ENGINE - REPLACE AN960 SERIES WASHERS - CATEGORY CODE 6 - MOD.ENG-72-0081

V2500-ENG-72-0081

Replacement of Washers - Fuel system Air Tubes
Fig.12

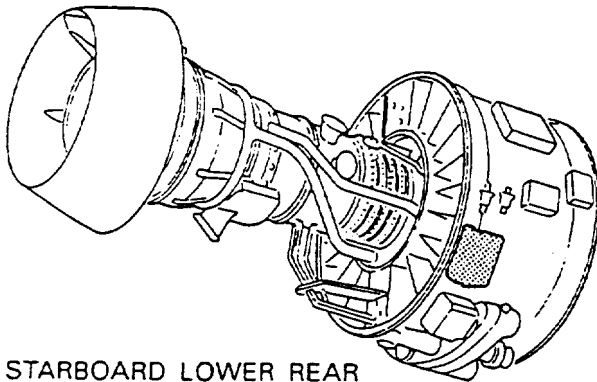
- (12) At CP1026, install the new 5W1086, Washer, to clamp Fuel System Air Tube by the approved procedures in the Engine Manual, 72-00-32, Installation, TASK 72-00-32-420-003. (Refer to Fig.12, and 1.K. References (1) and (2)).

Replacement of Washers - Air Cooled Oil Cooler

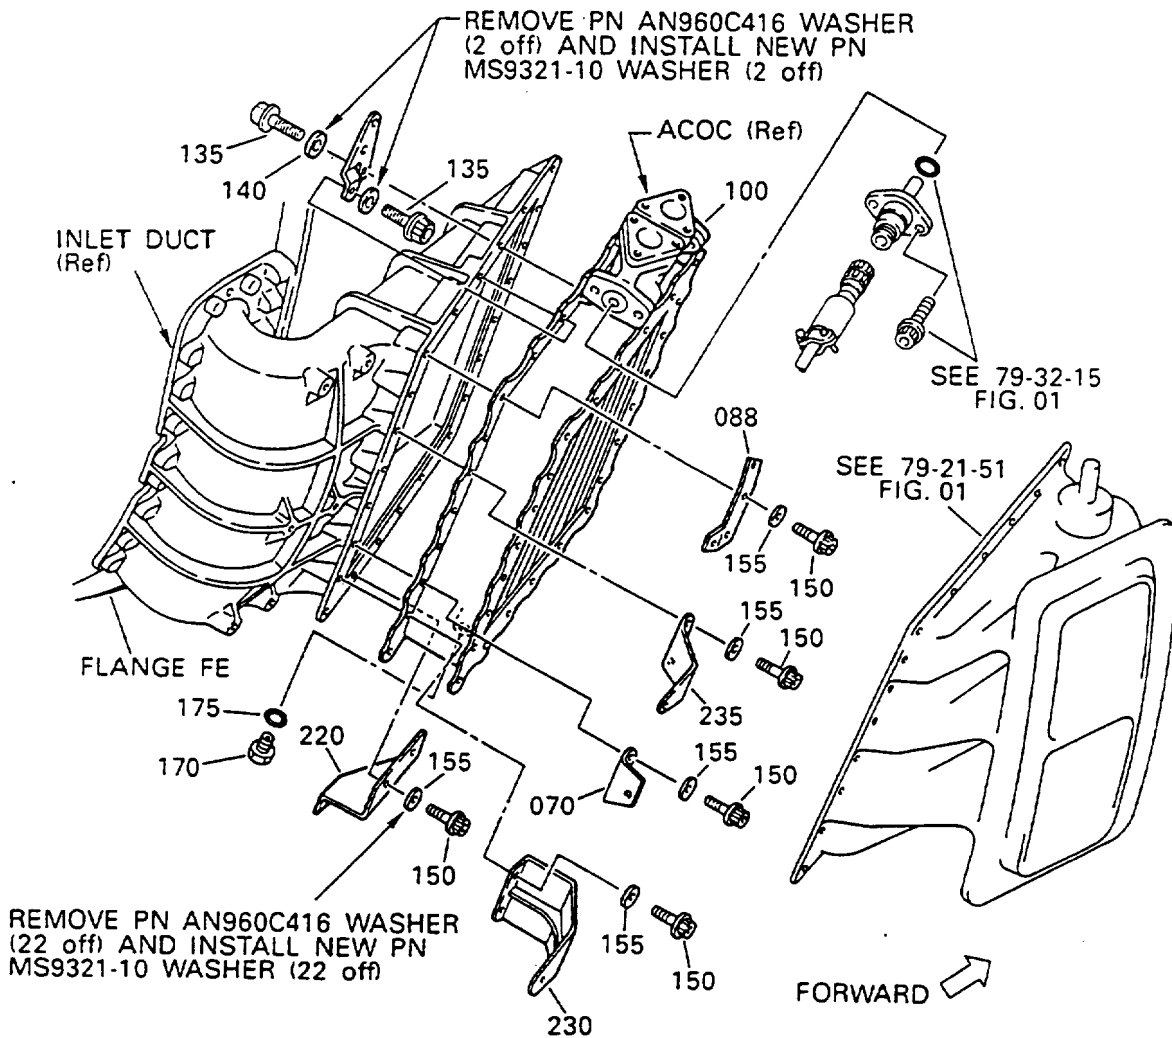
- (13) Install the twenty two new MS9321-10, Washers, to attach the Brackets to the Air Cooled Oil Cooler (ACOC). (Refer to Fig.13, and 1.K. References (1)).

- (14) Install the two new MS9321-10, Washers, to attach the Bracket to the ACOC and the Inlet Duct. (Refer to Fig.13, and 1.K. Reference (1)).
- (15) Install the five new MS9321-11, Washers, to attach the Cap A/O to the Fuel Cooled Oil Cooler (FCOC). (Refer to Fig.14, 1.K. Reference (1)).
